ALTERATIONS AND ADDITIONS 49 GRANDVIEW DRIVE NEWPORT LOT 25 DP16029		
CLIENT BEN WEATHERALL AND MARIELA SANCHEZ		
LOWER GROUND FLOOR PLAN		
DATE JANUARY 2021	DRAWN J.WRIGHT	DRG. NO. 01-21-GRA
SCALE 1:100	ISSUE: DA	SHEET NO. 1

Issue	Date	Revision
A	12-11-21	Eastern side wall stepped. Privacy screen added to eastern side of rear deck.

EAST AND NORTH ELEVATION

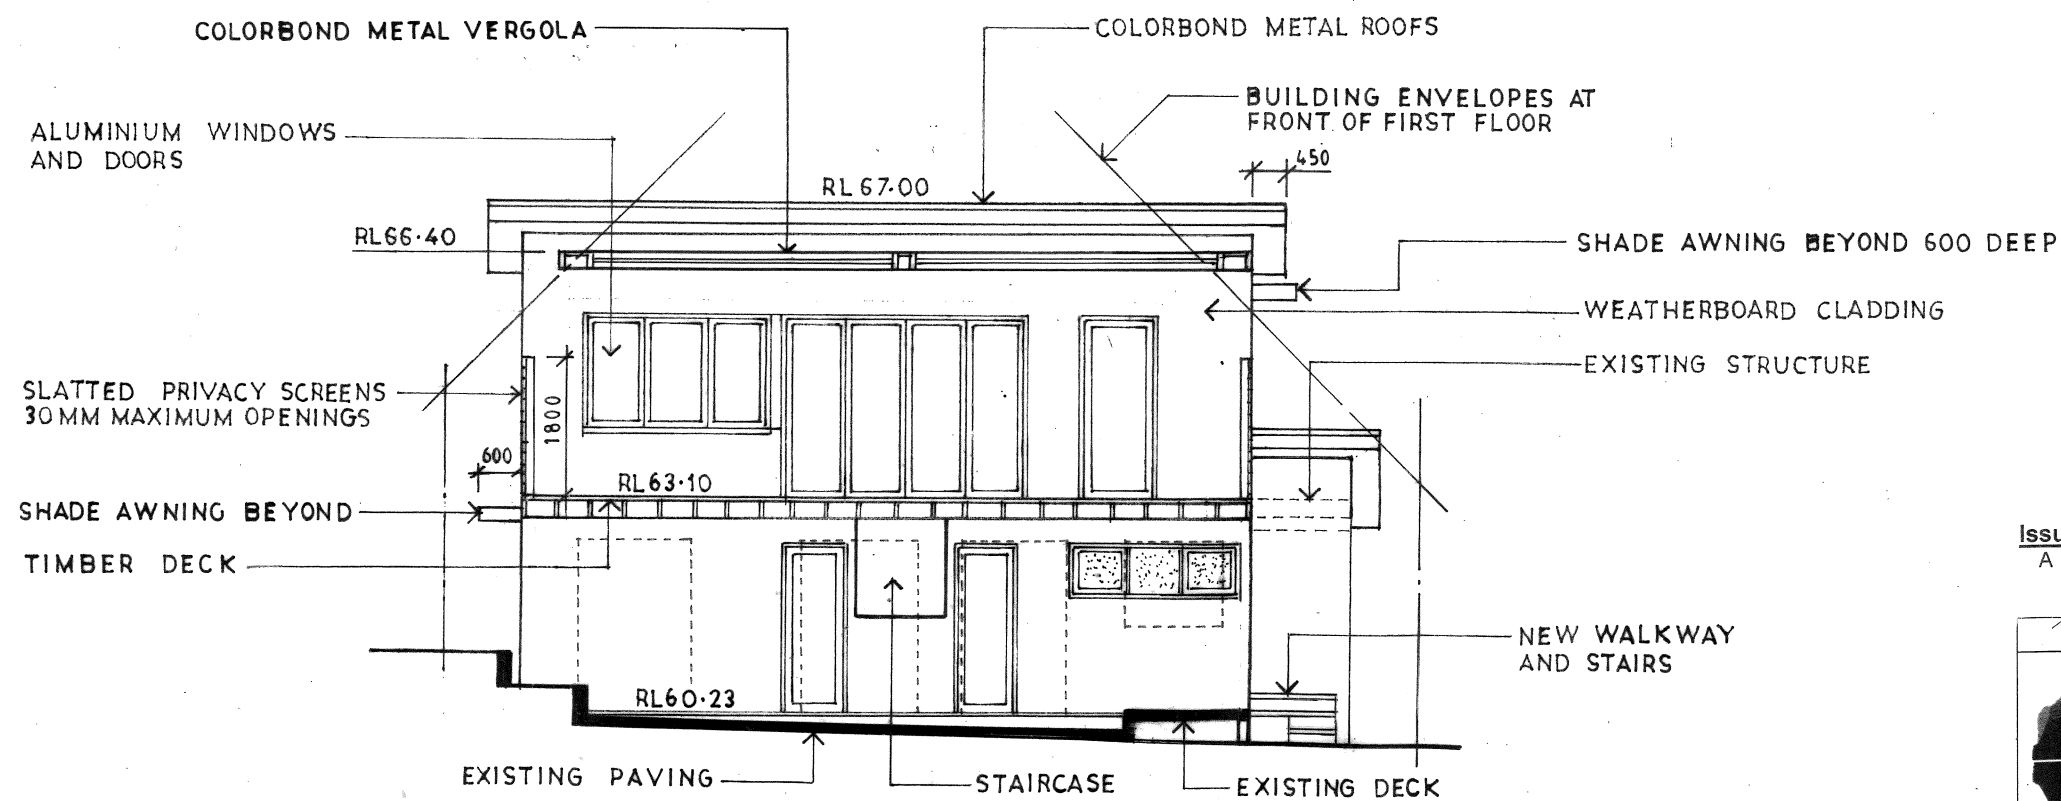
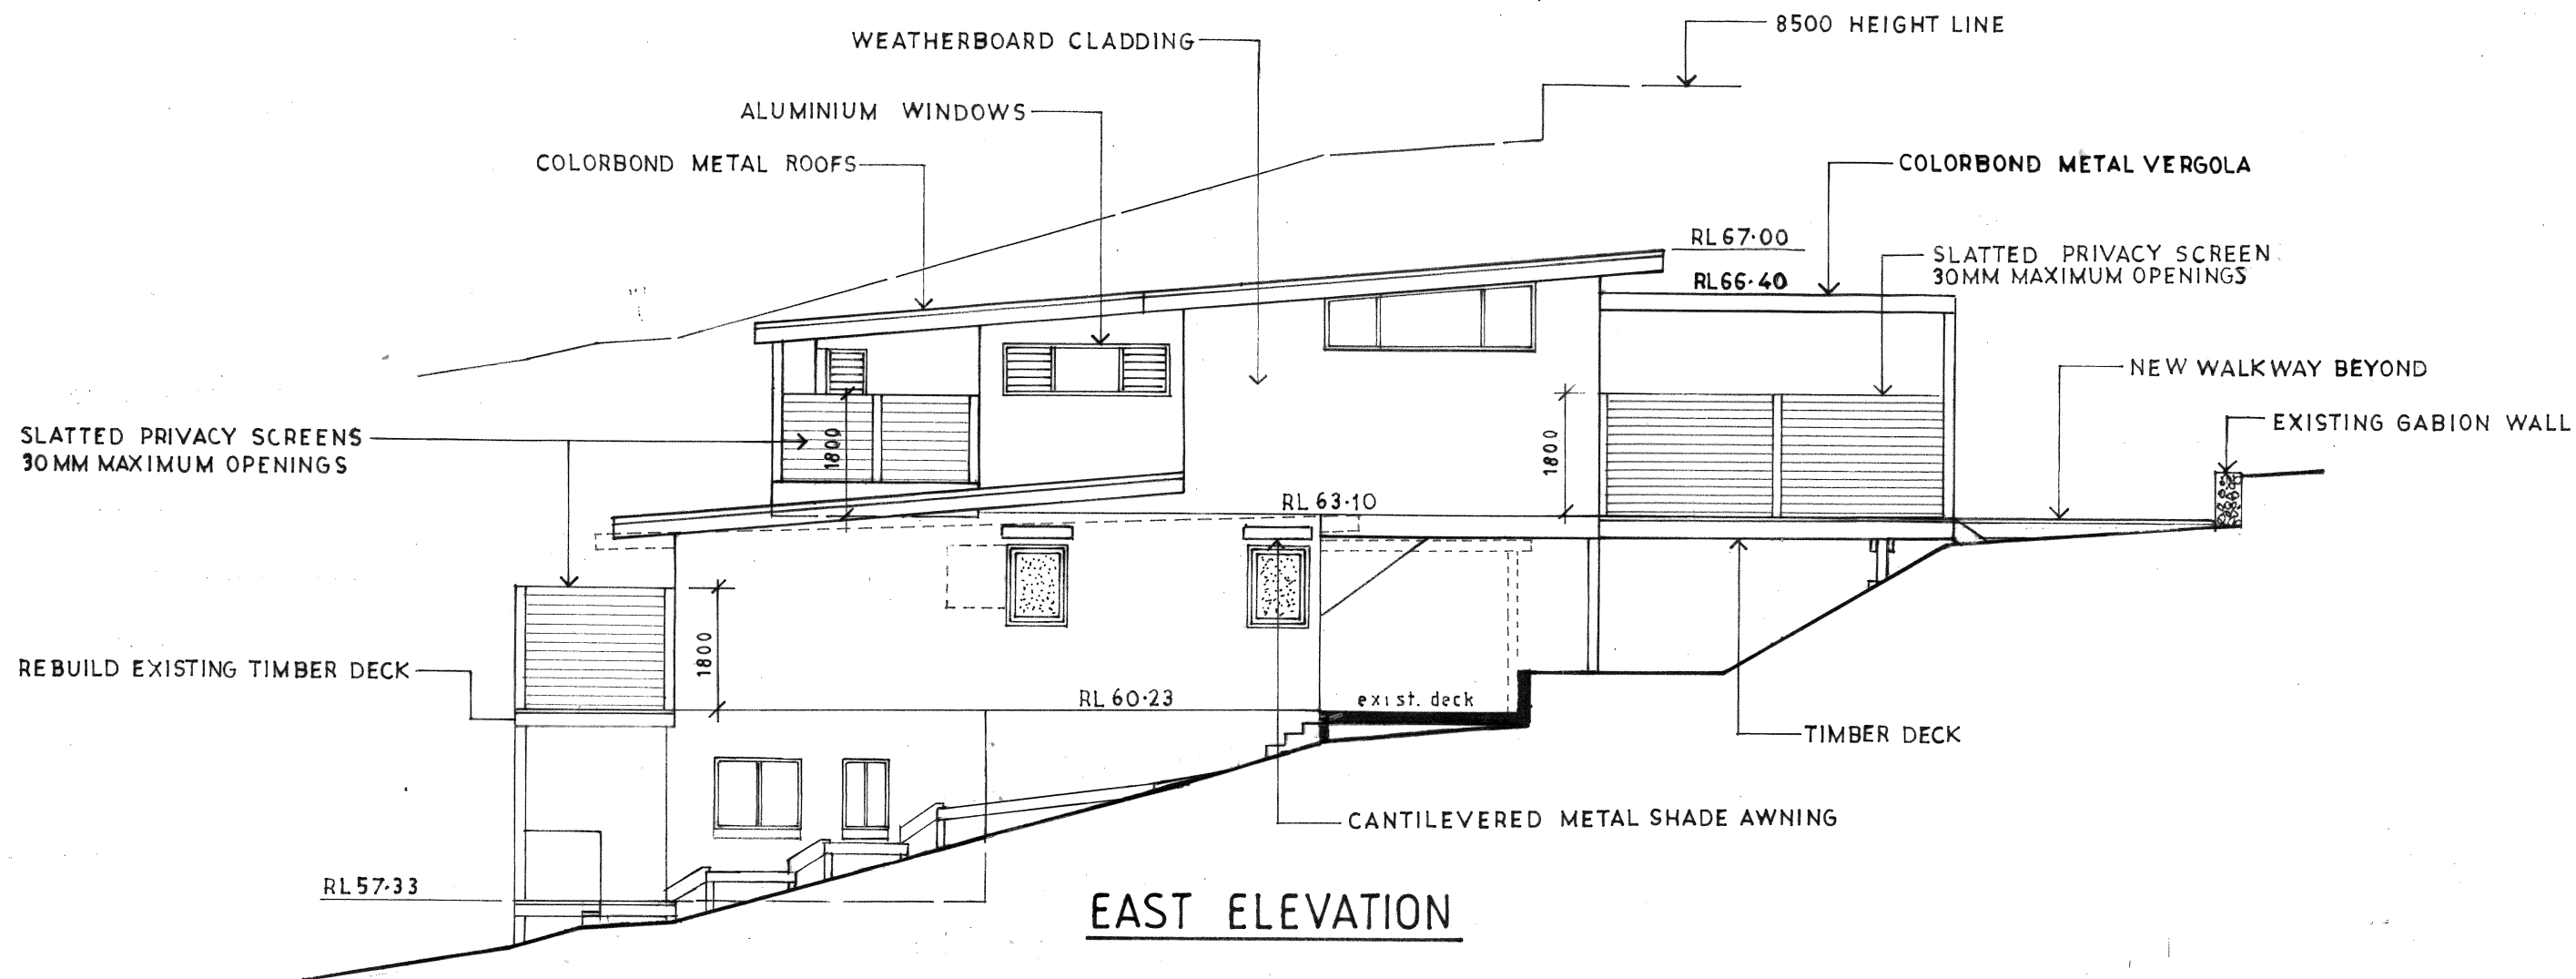
Issue	Date	Revision
A	12-11-21	First floor eastern side wall stepped and privacy screens added to eastern side of ground and first floor rear decks.

WEST AND SOUTH ELEVATION

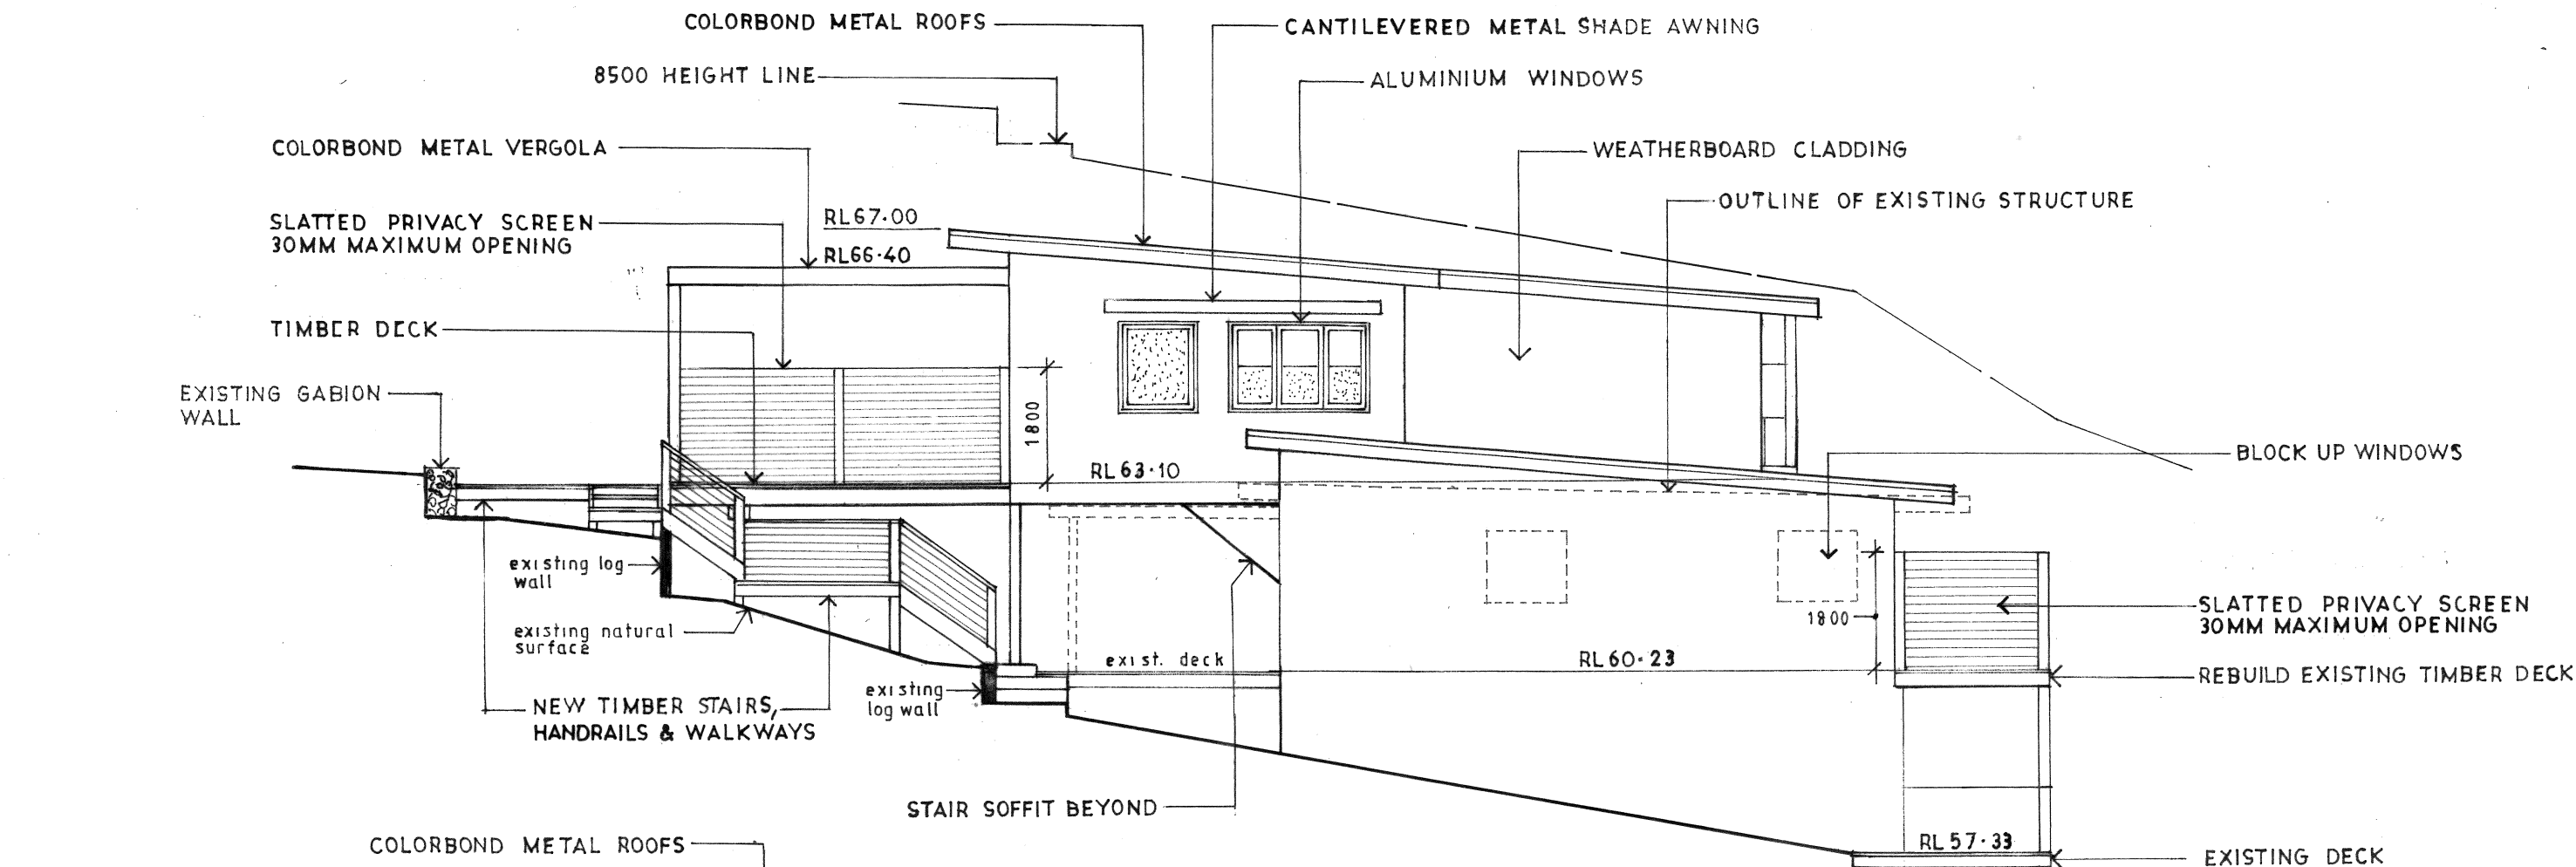
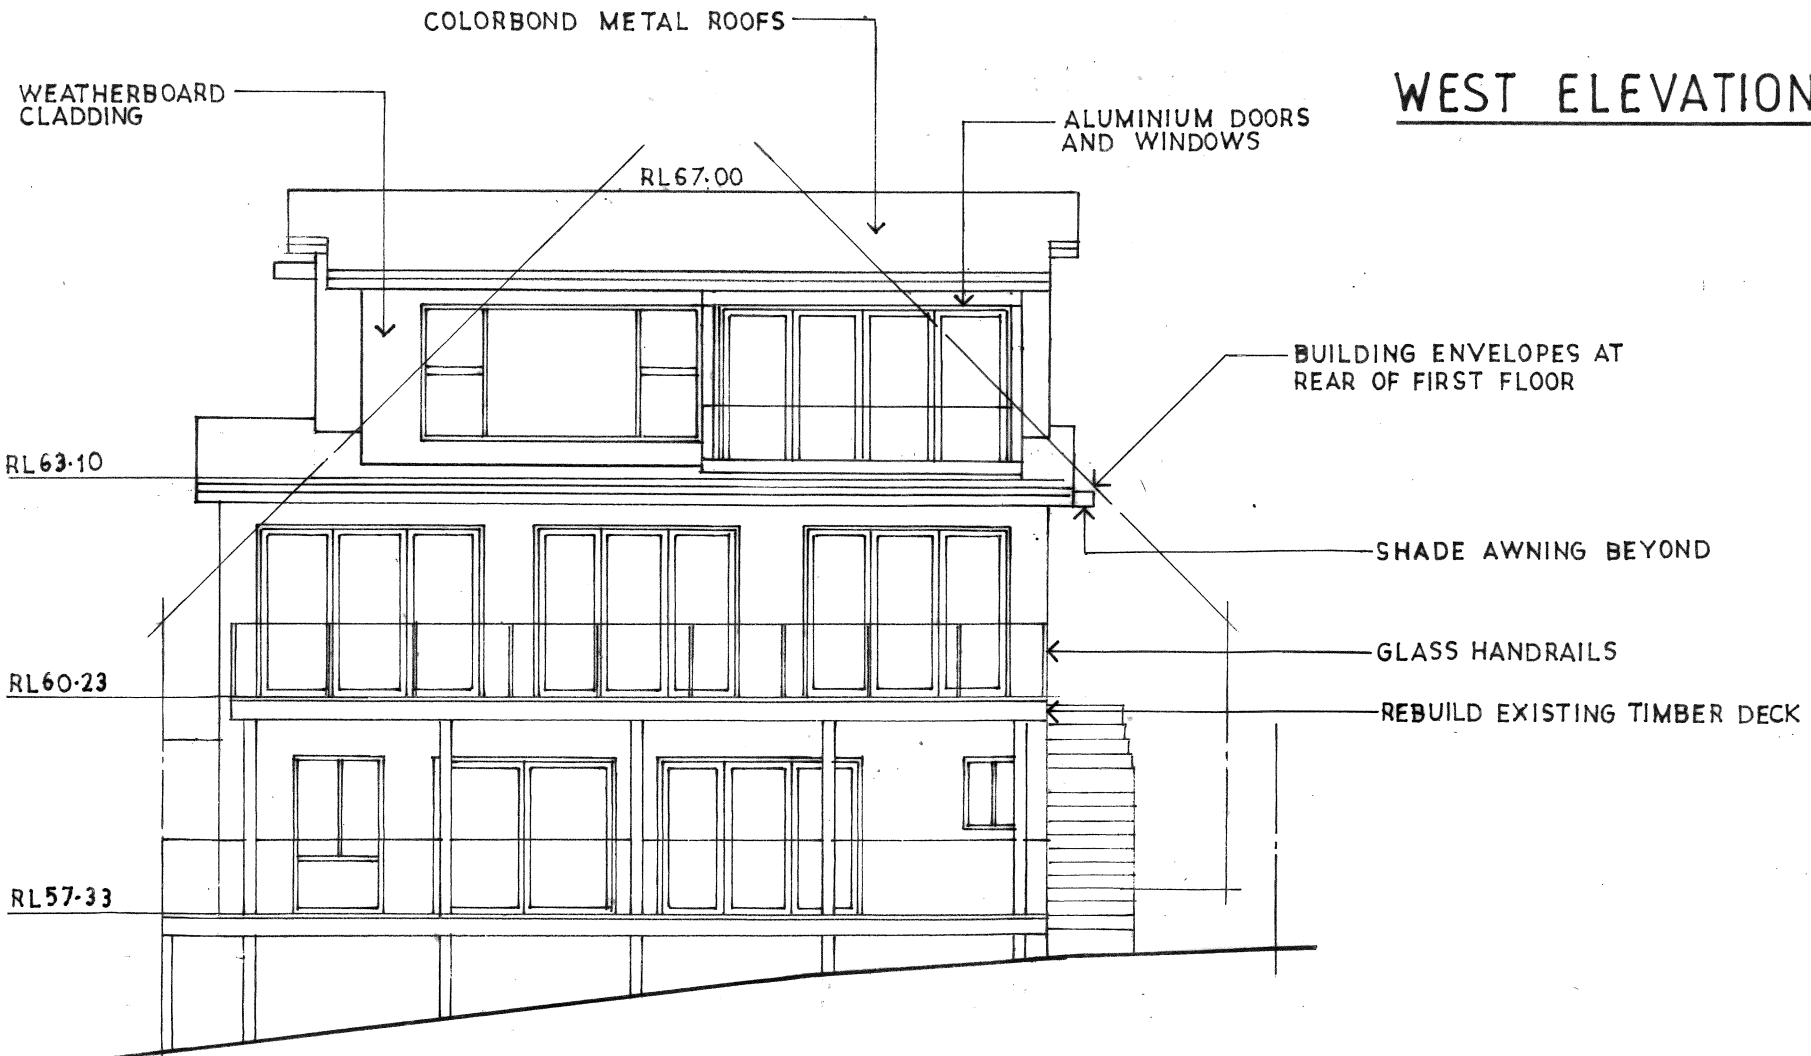
Issue	Date	Revision
A	12-11-21	Privacy screens added to both ends of ground floor rear deck. First floor eastern side wall stepped and privacy screen added to eastern side of rear deck.

ALTERATIONS AND ADDITIONS 49 GRANDVIEW DRIVE NEWPORT LOT 25 DP16029 CLIENT BEN WEATHERALL AND MARIELA SANCHEZ		
SECTION AND NOTES		
DATE JANUARY 2021	DRAWN J.WRIGHT	DRG. NO. 01-21-GRA
SCALE 1:100	ISSUE: DA	SHEET NO. 6A

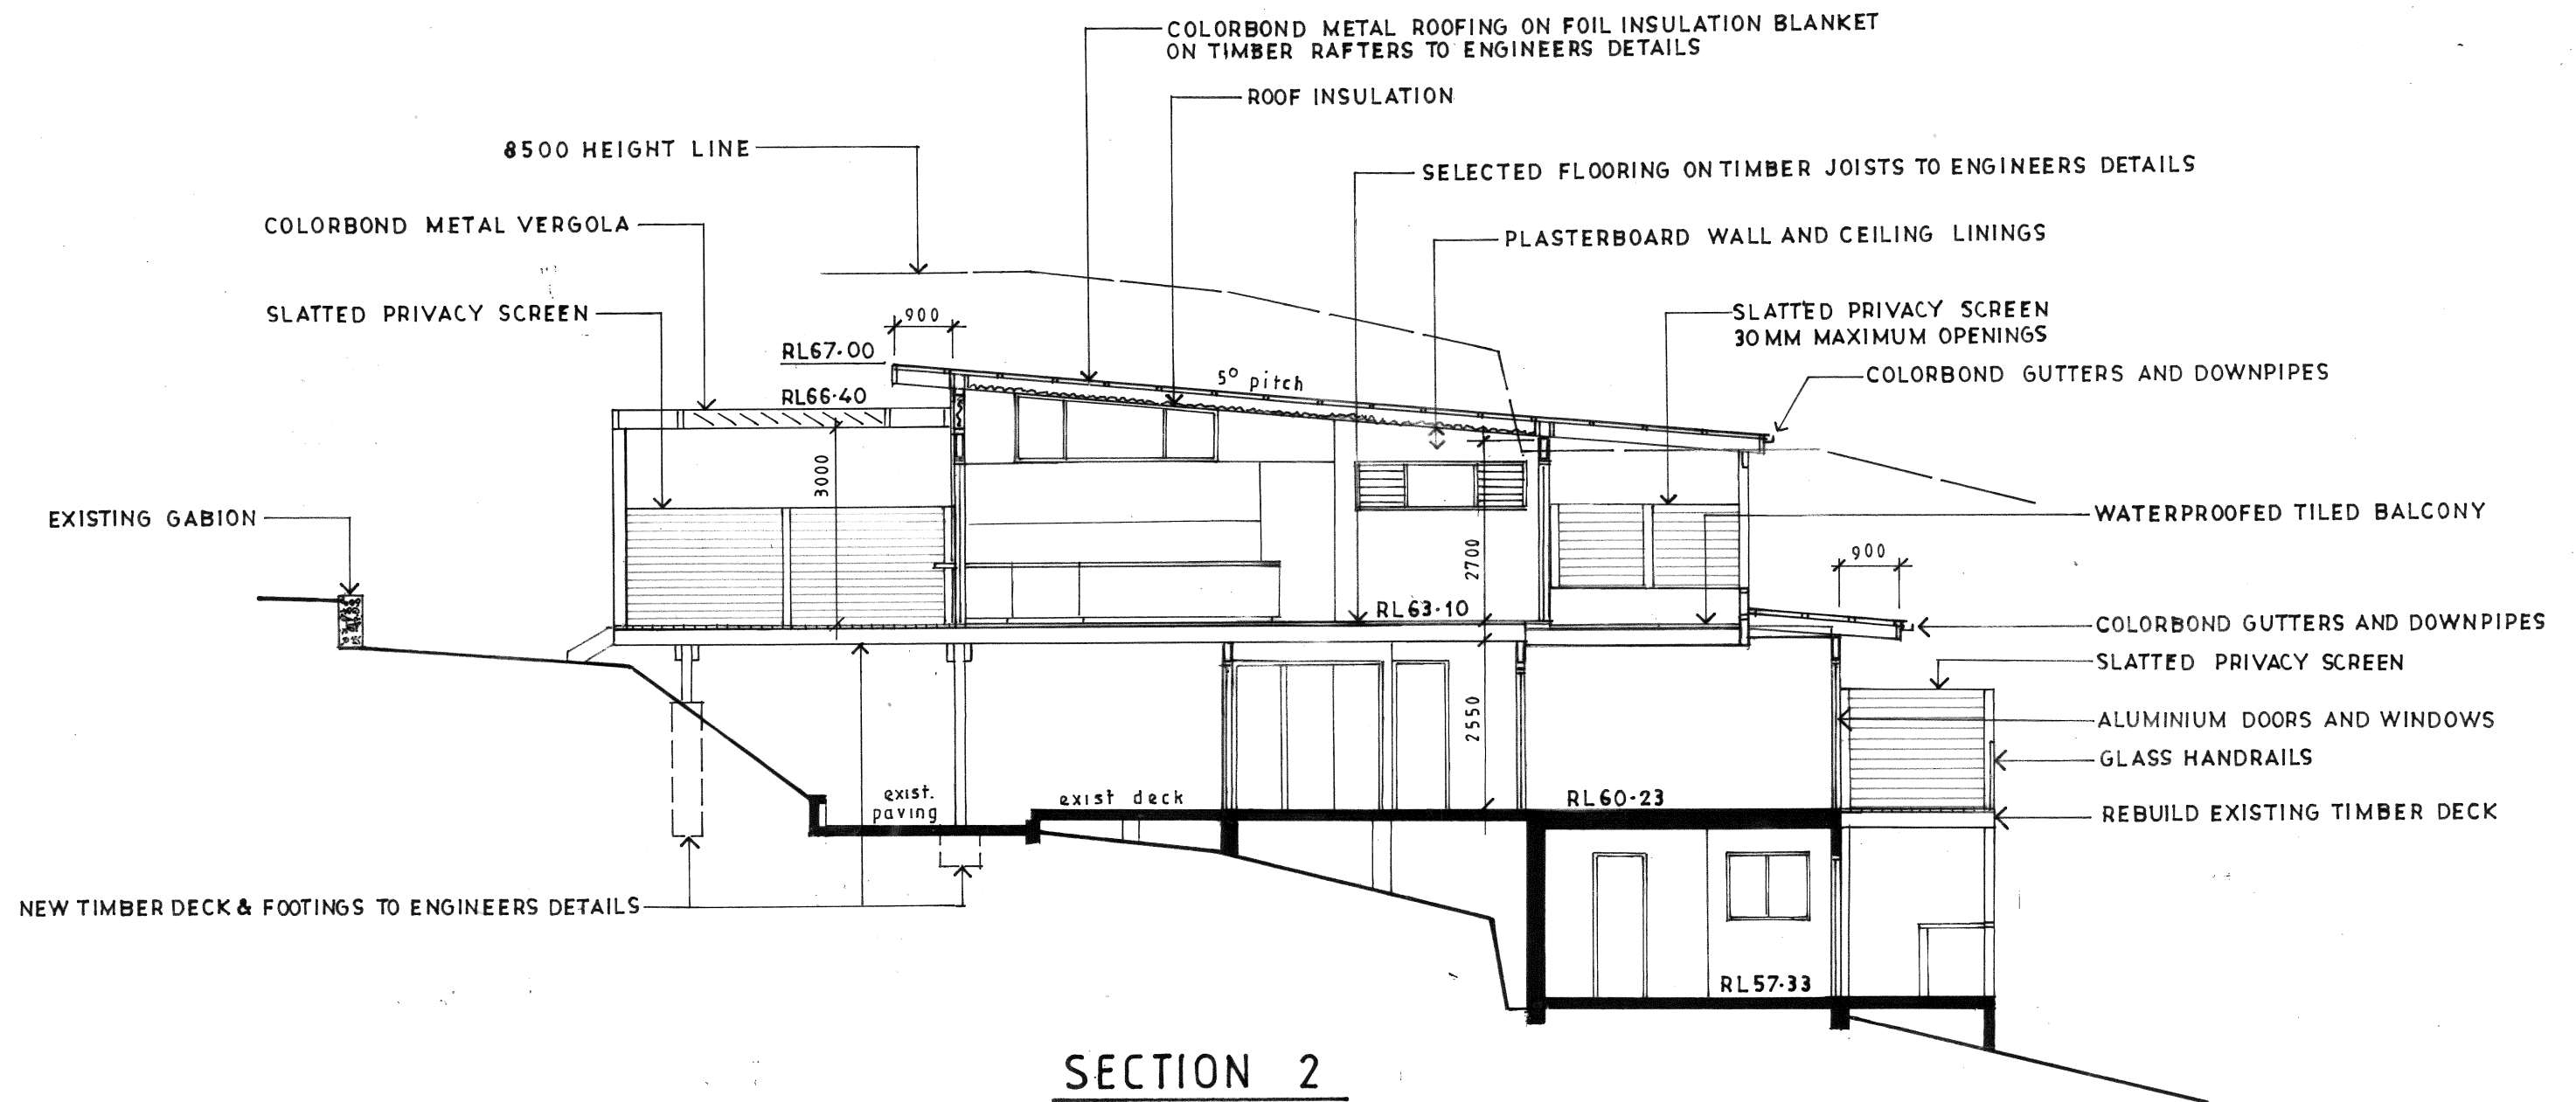
Issue	Date	Revision
A	12-11-21	First floor eastern side wall stepped and privacy screens added to eastern side of ground and first floor rear decks.
